TECHNICAL UPGRADE BULLETIN

Date: July 28, 2015	RE: TT/TTB/TTV HOSE UPGRADE
Model(s) ALL TT/TTB/TTV Units

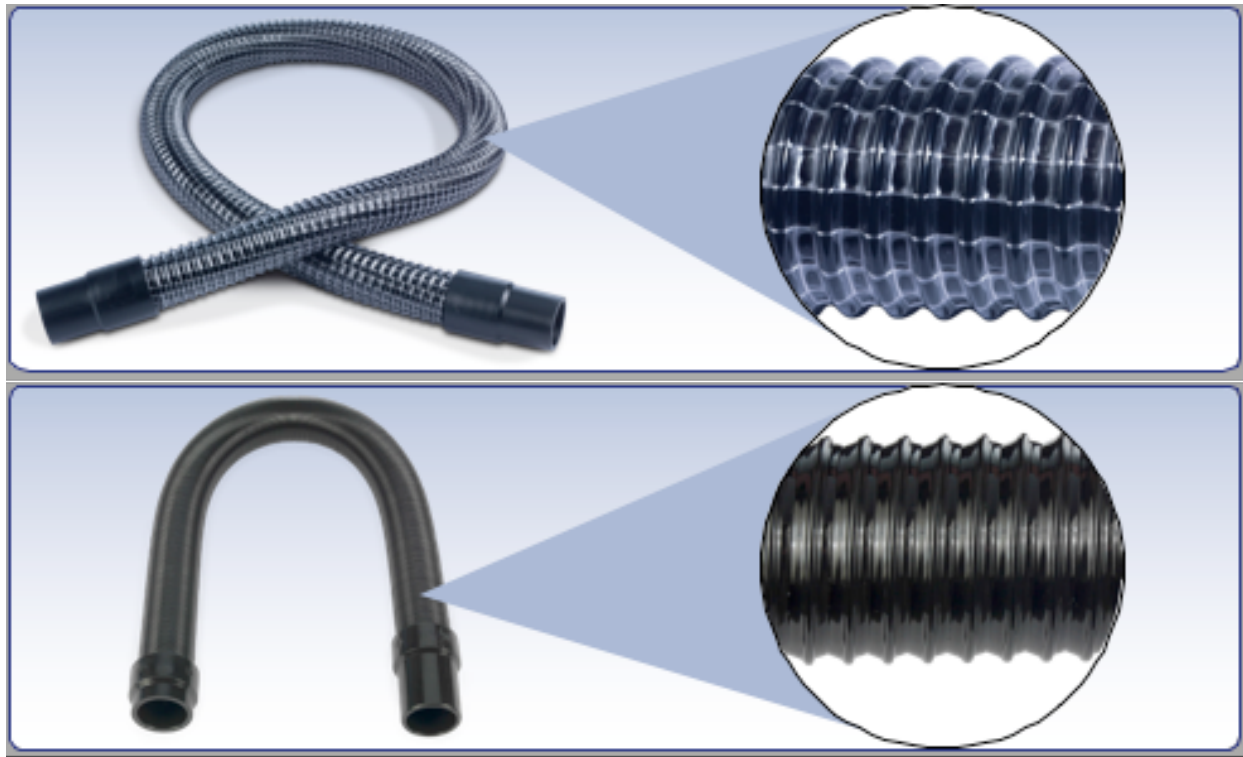
As part of NaceCare Solutions commitment to product support and machine upgrades we have upgraded hoses to a new more robust design. The stretch hoses have changed material from PVC (Polyvinyl Chloride) to a PU (Polyurethane) that provides extra durability.

Shown below is the new suction and floor tool hoses.
